Mortdale State Significant Development Application Response to Submissions Report

APP Corporation Pty Limited

April 2017

Figure 3: Proposed processing plant at the Mortdale facility
 Source: SKALA

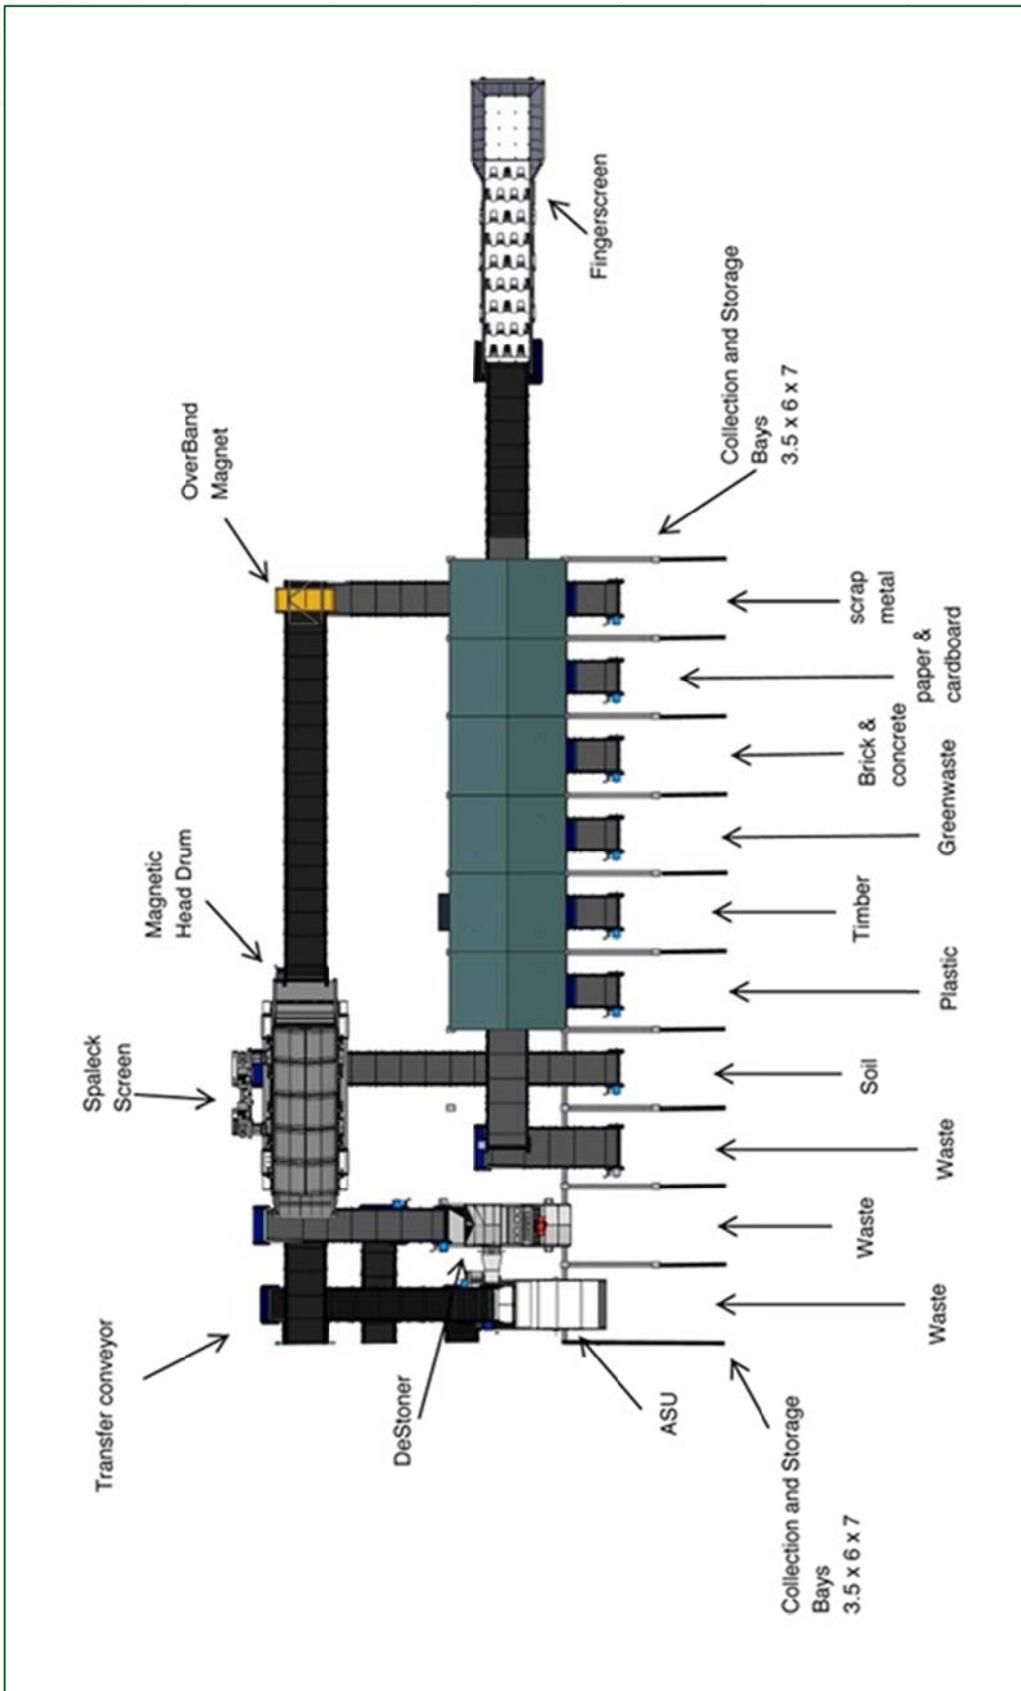
Process		
6	<p>The explanation provided is inadequate. Whilst the processing capacity of the machinery may be sufficient to process (more than) 300,000 tpa of waste material, the Department's concerns also relate to the size of the site and its ability to support this amount of throughput. Provide full details of the method for processing waste materials including:</p> <ul style="list-style-type: none"> unloading procedures and timeframes, especially in relation to the situation where the site is fully "stacked" with incoming trucks. How long would it take to unload each truck and how would this affect build-up of trucks behind it given only one truck can unload at any one time? storage timeframes; processing timeframes; quality control; outputs; and methods for loading and removal from the site. <p>In particular, information should be provided regarding the site's capability to store and process the waste received during night time, whilst still receiving more waste during the day without excessive build up occurring i.e. there would be no processing between 10pm and 6am while, according to Appendix A – TIA letter, 26 truckloads of waste are predicted to be delivered in this period, with another 17 truckloads between 6am and 7am.</p> <p>Further details should also be provided regarding the machinery (screens etc.) proposed for waste separation, as well as the method of conveyance of separated products into the material bays prior to removal.</p>	Section 4.1.5

SKALA Australasia Pty Ltd (Skala) was commissioned by the business operator to design, supply and install the plant and machinery for the Mortdale facility (**Figure 3**). Skala is a service and equipment supplier specialising in bulk material handling and vibratory process equipment. The following provides a description of plant functionality by Skala:

Figure 4: Traffic Controls at Site Access

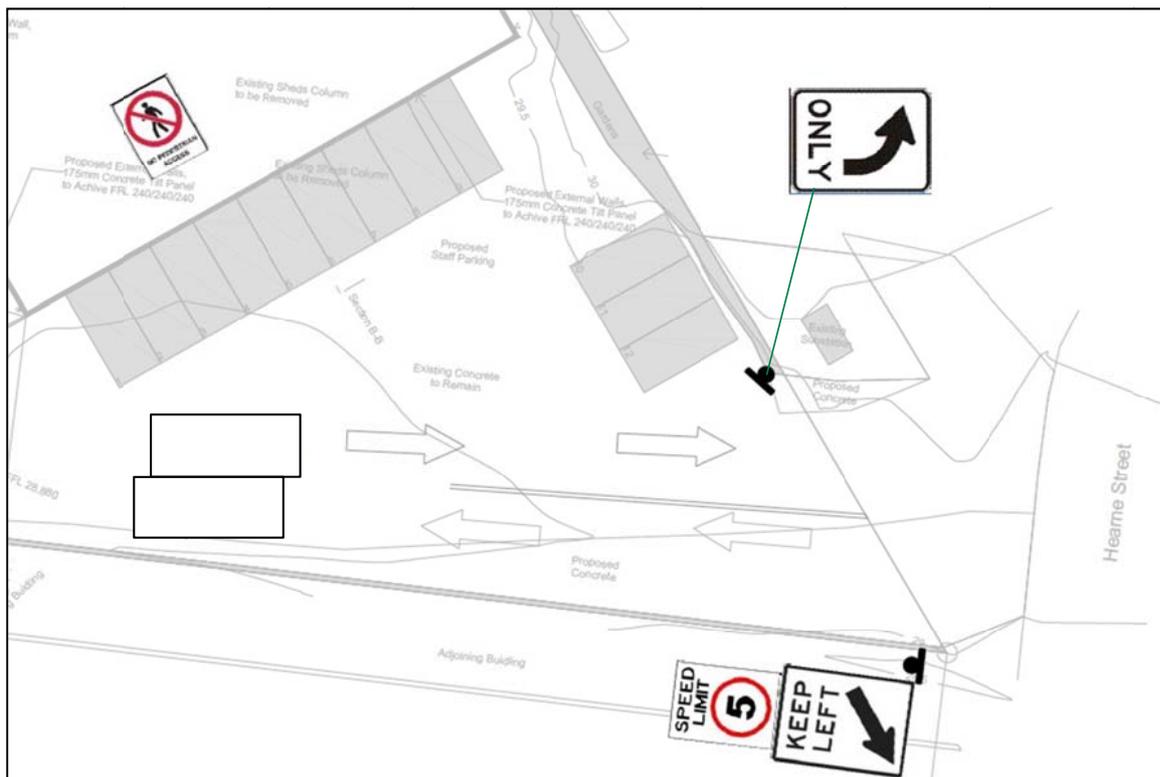
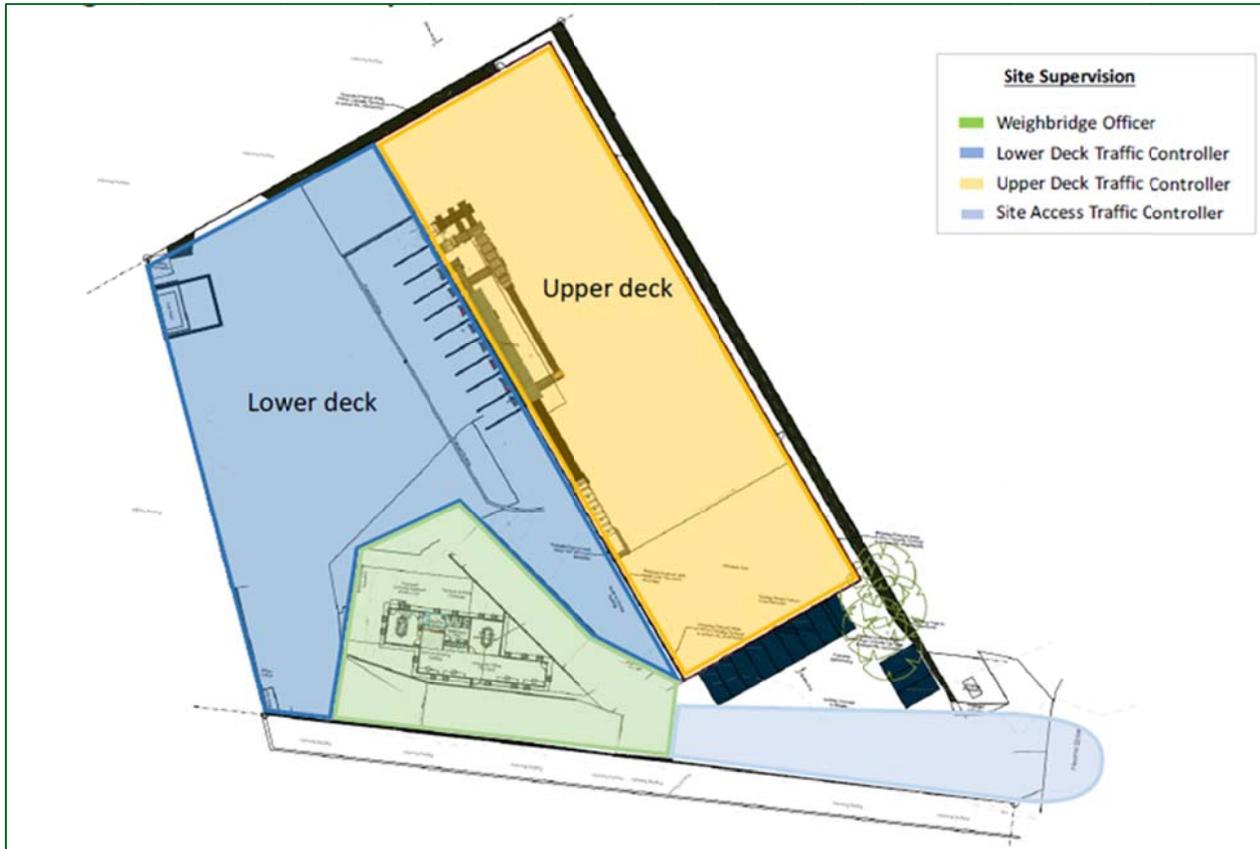
Department of Planning		
Traffic		
No.	Agency Comment	Response Section
1	Additional information provided in TIA Letter, however the information lacks any detail regarding management of trucks at the site entry. Figure 2 depicts traffic controls which are all internal - there are no proposed controls at the entrance to avoid conflict with vehicles entering and exiting. If an exiting truck takes a wide berth, an incoming truck would not be able to enter. Further details are required regarding management of vehicles entering and leaving the site to avoid queuing within the road reserve and traffic safety issues.	Section 4.2.1 and Section 4.2.4
2	A stacking plan has been provided which only shows the stacking of heavy rigid trucks on site. There is no plan showing the stacking of semi-trailers collecting sorted materials. There is no indication of how traffic will be controlled at the access way. In particular, how will trucks be directed to the stacking locations. Further, the stacking plan contradicts the internal turning path diagrams with vehicles stacked in areas required for manoeuvring. Further clarification is required.	Section 4.2.3

TTPP have prepared a comprehensive response to the issue of road safety (**Appendix C**) and recommend the following additional measures as reflected in **Figure 4** and **5**:

Figure 6: Semi-Trailer Swept Path and Stacking Plan

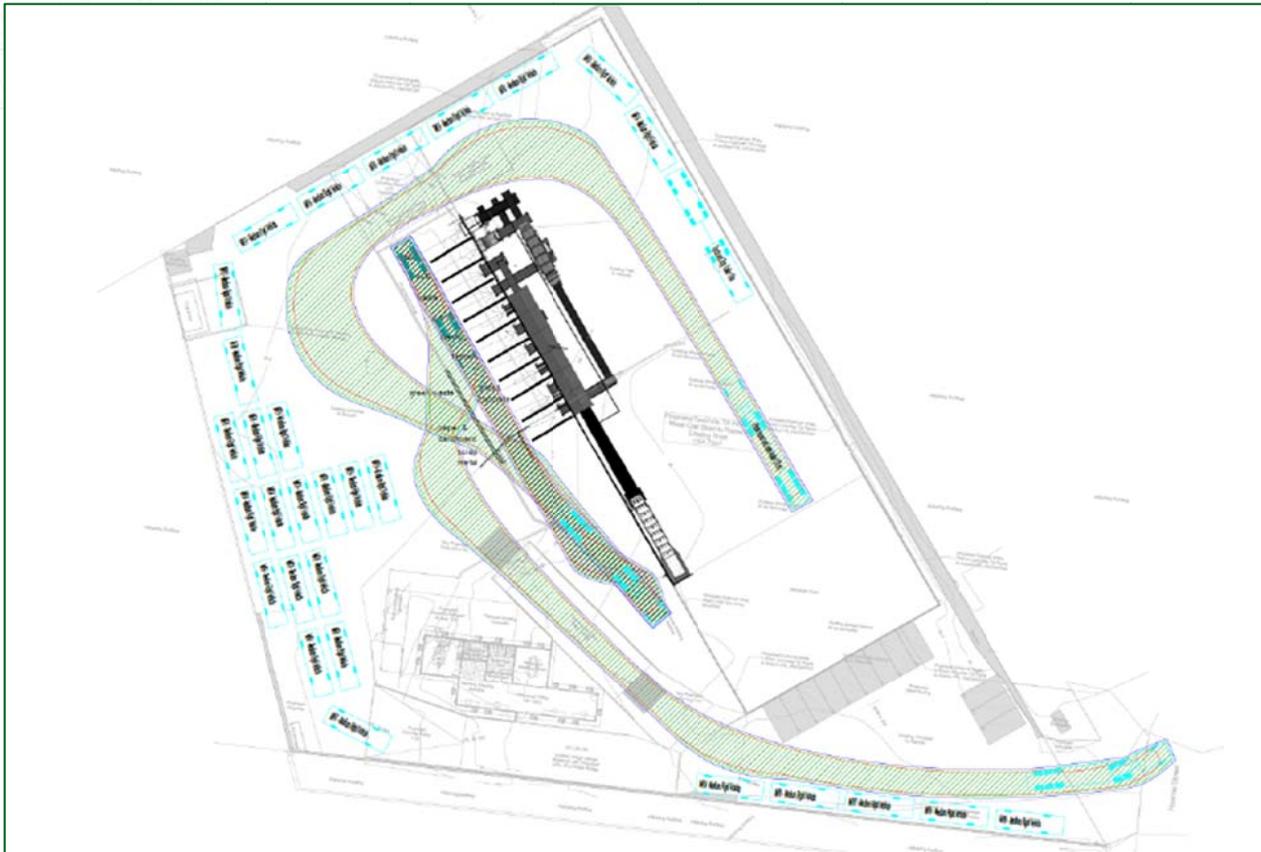
The DP&E sought clarity on a perceived conflict between the stacking and swept path movements. TTPP prepared an updated stacking and swept path plan which identified no conflicts between these procedures (**Appendix C**). TTPP have also advised that the reduced vehicle flow will ensure trucks will be wholly accommodated and managed within the site. As a result of the proposed stacking, traffic control arrangements and reduced peak vehicle movement, heavy vehicles are not expected to queue back onto Hearne Street.

3	Exiting trucks have been placed in a location which contradicts the stacking plan diagrams (see below). This requires amendment.	Section 4.2.33
Waste		
4	No clear indication is provided as to the number of days per year that 24 hour waste delivery would be required.	Section 4.1
	Would night time deliveries occur every day?	Section 4.1
	Where are the 60 sites used for disposal? Is there a main buyer of the recycled product?	Section 4.1.2
Water		
5	Is there an alarm system to indicate when the leachate sump is full?	Section 4.1.6
Stockpiles		
12	It is unclear how the information provided addresses this issue. The Department requires information regarding the dimensions of the designated stockpile areas of the site where unprocessed and processed waste material would be stored. If 10,000 tonnes of material were to be stored on the site at any one time, would there be sufficient space for this? Details of the storage capacity of the site should be provided and demonstrated to be adequate.	Section 4.1.4

The swept path of a 19 metre semi-trailer travelling from the tip floor to the storage bays and site exit indicates that vehicle movements can be achieved without conflict. The 31 stacking spaces are also shown on this plan and include two semi-trailers of 19 metre in length to highlight that the swept path does not clash with the queuing trucks. The on-site stacking plan for waste delivery vehicles is provided at **Appendix C**.

Figure 10: Updated Fire Safety Plan
 Source: SLR

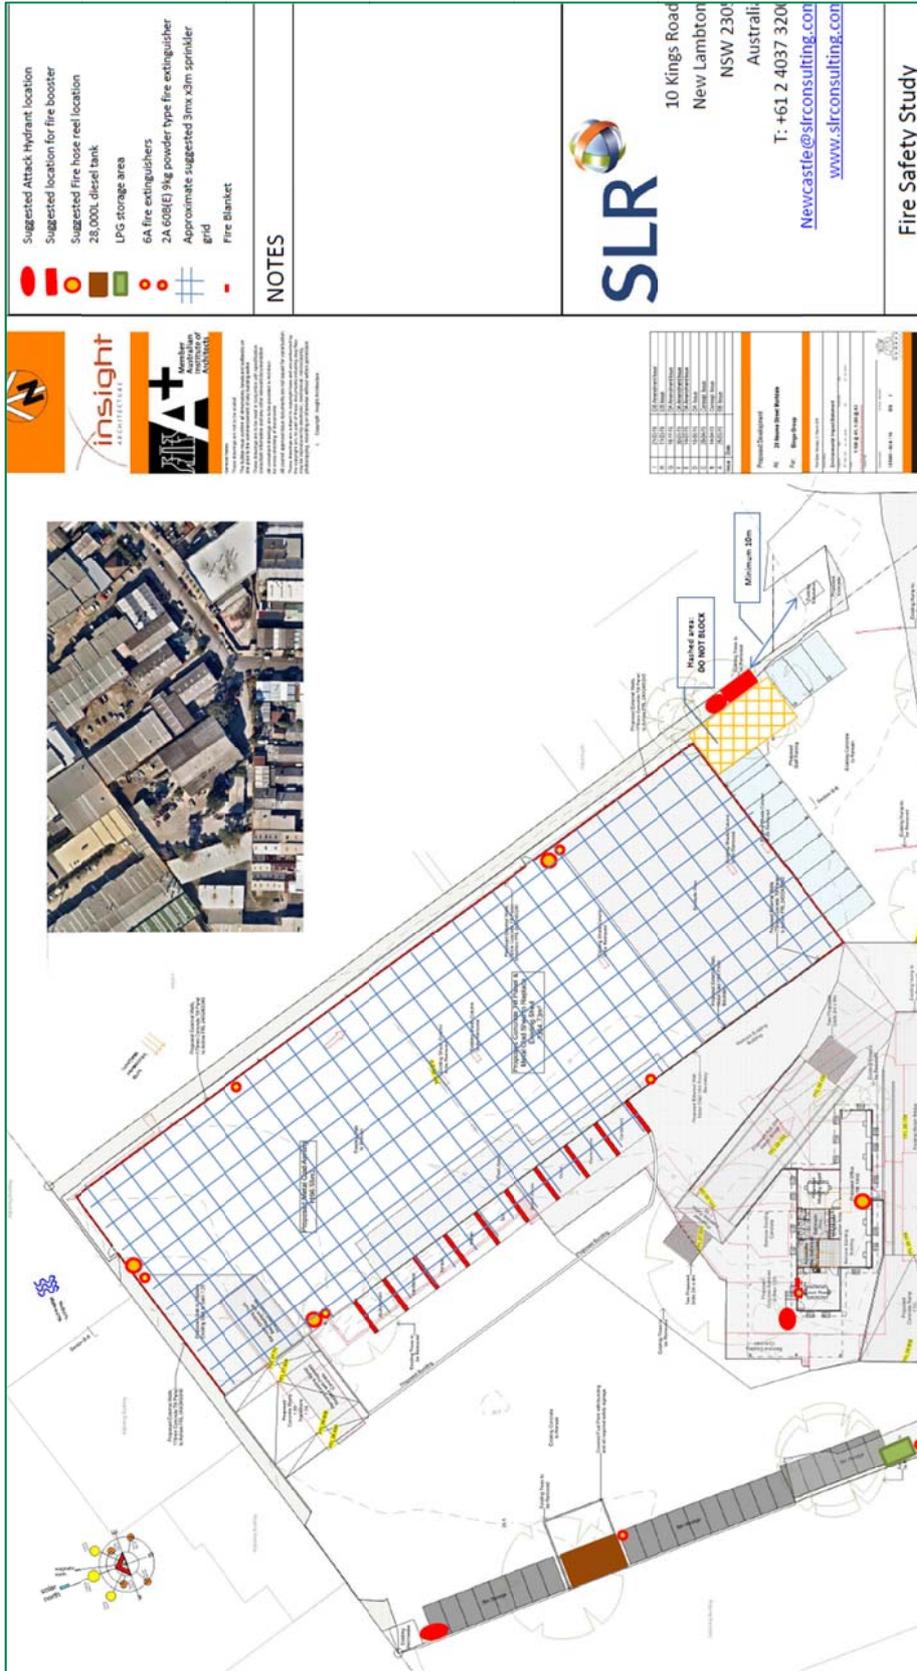
- A full assessment of the (FSS) is required to be undertaken by FRNSW pending approval;
- Does not support the proposed location of hydrant booster assembly and attack fire hydrants nor does the fire hydrant system meet the requirements of FRNSW;

- Details on sprinkler booster assembly or any associated dedicated firewater storage tanks have not been provided;
- The hydraulic design should cope with any hazards and the consequence thereof;

SLR prepared a revised plan (**Figure 10**) showing alternative locations for the booster and the attack hydrants as well as a response to the matters raised by FRNSW (**Appendix D**). SLR recommend that the necessary detailed design and calculations are best prepared as part of the final design. Following approval of the project and once this information has been prepared, a site meeting will be held with FRNSW to finalise the design to meet FRNSW requirements and resolve any outstanding issues.
